Meeting Summary

Junipero Serra Trail Feasibility Study

RE: Community Meeting #2a and 2b

II. Trail Design

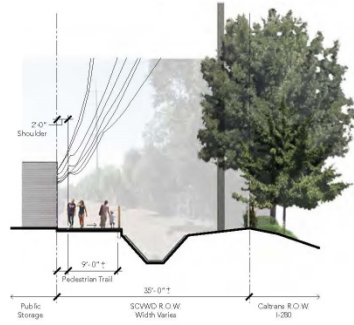
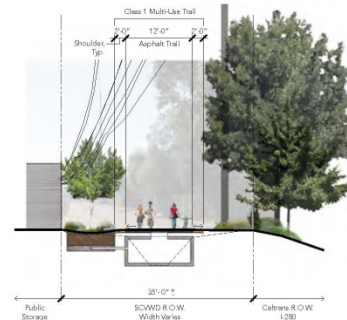
- Cost: significantly more for alternative #2. Use: Alternative #1 will be used multi-use anyway.
- Wider, multi-purpose, dream big - one time cost
- Wider trail, safety that someone not going to fall in ditch.

- Safety
- Multi Use - Bike and Pedestrian
- Safety, traffic, parking, noise, lack of privacy, Increase of strangers in the area
- No bikes, lighting, noise, less privacy, security

- Open Space. It would provide a better experience.
- Impact of people and traffic
- Aesthetics, Width-allows easier bike + pedestrian traffic
- Separation from traffic

- Allowing bicycles on the trail is vital in order for the trail to provide a good commuting alternative
- Potential users; impact on privacy, security of residents along trail; reversibility; potential impact to water authority activities

- More room for ped and bike
- Trail width
- I like the extra width provided by Alt #2, but I think Alt #1 would be much simpler and less expensive which will help it happen! Would particularly be concerned about limiting water flow or complicating maintenance when covering the ditch. Alt#2 also adds some additional green buffer to neighbors, but I don't think this will be a problem after it is constructed

- Safety, security, noise impact, privacy for those houses impacted
- This is the "aging of America" (I don't think this is being considered). The aged are not going to be riding bicycles (nor walking over bridges/trails) to get to their medical appointments or bring home groceries, etc. We have enough bicycle/access infiltrating our area, bringing in outsiders. These "designs" will impact the quiet enjoyment of our homes even more!!

- Walking along a trail built right next to a major highway is not something of great appeal; physical and environmental safety concerns (i.e. fumes from many motor vehicles, noise) will

not be great appeal; Building and maintaining such a trail, built next to a major highway will be much more expensive? What is the projected cost?

- The proposed trail would run directly behind my house, it would impact my privacy as well as increase the noise level
- Safety of existing redwood trees along 280; presence of bikes and pedestrians on same trail - how safe?

- For the second alternative, there is more space for people to commute to work, or go on a family walk. For people going to work, it is a longer commute by bike without the trail

- It would be cosmetically nicer and it might keep out any random undesirable smells
- I am concerned about security for property owners next to the trail. As is, there is graffiti on I-280 sound wall

- Multi-use trail more useful than narrow pedestrian only trail
- It is wider, it looks nicer, there is more greenery
- This is for Apple-only and don't care about us who live next to the trail

- Consistent width, avoids falling in ditches, more visually appealing, avoids conflict with location on PG&E poles, especially in Station #4 area
- Width! The wider trail is safer to allow pedestrians, bikes, skateboards, etc.

STATION #3 - Mary Avenue Trail Access

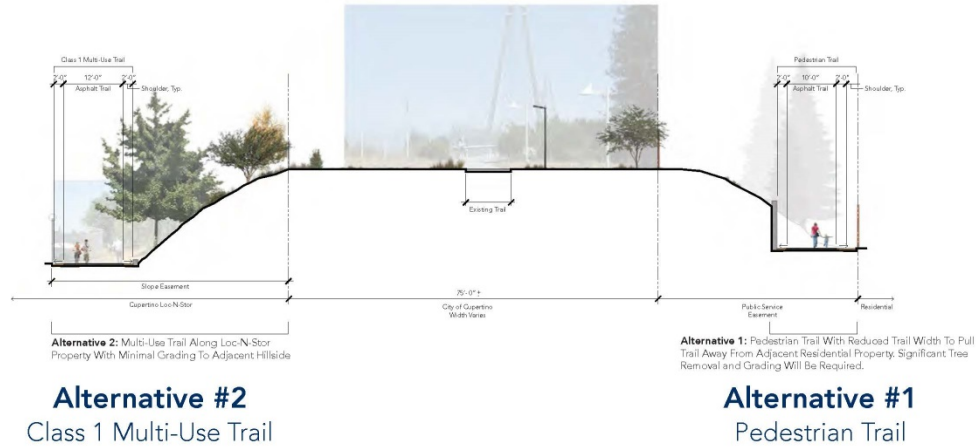
- Wider, bike friendly
- Do the right thing. If trail is not proper and wide it won't be usable and people won't use it. Having wider trail is right idea.
- Safety
- Multi Use, wider trail
- Security, noise, lighting, privacy
- Terrible proposal
- Width of the trail being better for multiple uses - pedestrian and bicycles; plant a new tree or bush to replace tree removed.
- Maintain trees along residences

- Slope is more natural and pleasing. In an emergency, trail users can leave the trail by climbing the slope; sharp easement feels walled in.
- Security underpass area

- Pleasant landscaping
- Easier, cheaper, better
- Again, making a choice for a simpler solution has a better chance of getting approved and built; I would encourage you to maintain as much natural screening as possible and NOT excavate more to create neighbor isolation; the perception of the negative is greater than the reality

- Why can't the existing Mary Ave. bridge on-ramp be used to access trail? That will reduce the project costs. Alternative 2 is my second choice, do not support Alternative 1

- See former page [Trail Design]
- Concerns over expense of such a project versus the benefit to public. Do not believe this project will have a great deal of appeal to most people

- I am not in favor of either alternative especially because it will be right behind our house/property. This trail would be an invasion of my privacy. The foot and bike traffic would result in noise and debris left on the trail

- Amount of water flowing in ditch
- Alternative #2 is safer in certain situations since you can escape up the hillside (unless you have parkour skills, which most people don't). Also, if you are walking along the trail, if it is wider and next to a hillside, it would be nicer

- It would be better for any animals living there, would look nicer and possibly cost less :)
- Multi-use of bicycles
- Wider, I ride my bike long distance, bike riders need a wider trail

- Alleviates concerns with adjacent homes seems more scenic
- Width to allow safer multi-use and to get it away from the residential area.

STATION #4 - De Anza Boulevard

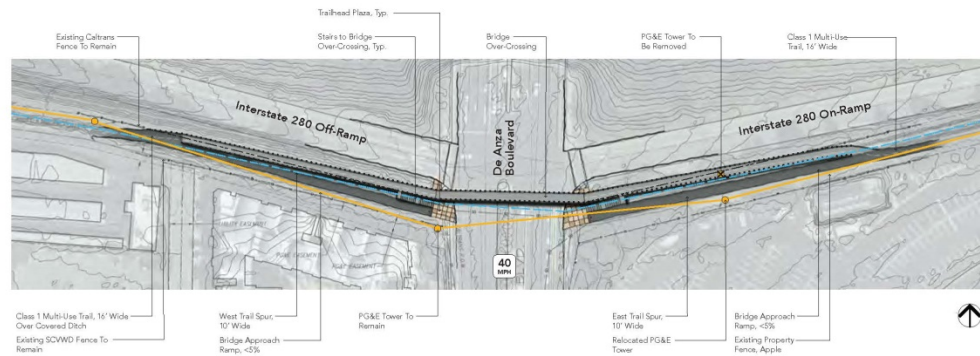
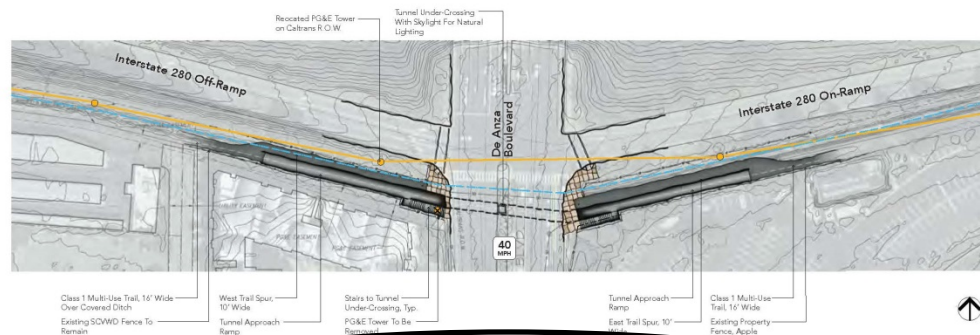
- Must have direct Apple access (infinite loop) to trail, to reduce bikes on Randy Ln/Larry Way. Limit access points to two: One east of Randy, (just far enough away from Apple to discourage parking) and one at Blaney. This grade-level proposal for crossing at Blaney is great.

- Informal trail access could serve as a pilot and could be upgraded if the trail use supports expansion
- Some convenience but less cost
- I prefer tunnel over bridge at De Anza mainly because of reduced elevation gain/loss; Use box culvert only when needed for trail width

Blaney Avenue with Trail Access on Lucille Avenue

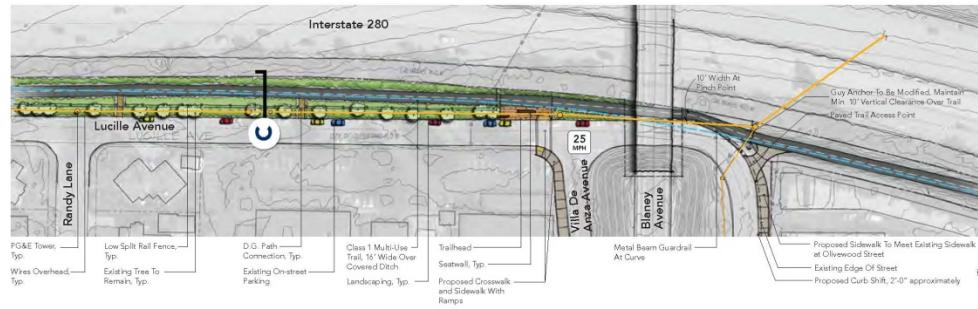
- Right next to my house. Privacy concerns. Live on Larry/Lucille.
- Privacy, parking, traffic are concerns for residents of Lucille, Larry and Randy. 1: Consider wall to help with privacy. 2: Big no to any access points on Lucille Ave.

- Not familiar with this section so no comment.
- No trail access on Blaney/Lucille
- Maintain fence - ideally make opaque for privacy. Make Lucille permitted parking M-F like Randy and Larry. Need frequent garbage clean up. Limited access - far from apple side to prevent parking problems. Maintain access under bridge for car traffic. Need police patrol for safety.

- I support none of these. I live here and would be impacted.
- Maintenance of trash can emptying would be very important
- Multiple access points make the trail more usable for people living in the neighborhood, and would provide trail users route options

- Mostly just need trailhead here; benches would be the only amenities needed
- How is security mentioned? Security patrol? How about people using trail for "hanging out"?

- Don't care...
- As shown
- Get Apple off the streets; safer alternatives for walkers/bikers; be mindful of neighborhood
- Section east of Blaney - no soundwall; trail users protection from vehicles leaving the road

- Provide access to Portal Ave. through CalWater site
- I live next to the trail on Randy Lane; trail would cause such a problem for traffic and people, let alone criminal activity

- Consider adding Trailhead/access point at the end of Lucille adjacent to the Apple campus. Work with Apple to create a linkage to Lawson Middle School along the edge of the Apple property, parallel to Larry Way, It would be nice to have some way to go directly from the trail up to the Blaney overpass.

- Do not put the additional access points in the middle of Lucille. Trail amenities needed: a map of trail, a bench, mile markers, lighting. Extra security around the main entrance & under the bridge. There has been tagging & dumping (mattresses, etc) in this area. Keep the road (Lucille) open under the bridge. Do not close it. The neighborhood relies on it to get to Homestead without having to cross Blaney. Critical to AM/PM traffic flow & school traffic.

- Might not be feasible
- Moving trucks double park and isn't safe
- Shift road to enable consistent class I

- Prohibit access in this area...not safe
- Add mirrors
- Redwood trees @ curb
- Trash & homeless
- Cut through lots of trash
- Hiding spot under bridge
- Homeless living in ex tunnel
- Taggers
- Can you put a sidewalk here?
- Parking concerns
- Safety - can you have call boxes? Mile markers
- Car theft (Lucille ave)
- Consider alternative fencing - that provides features of existing chainlink (e.g. animal/pedestrian control)
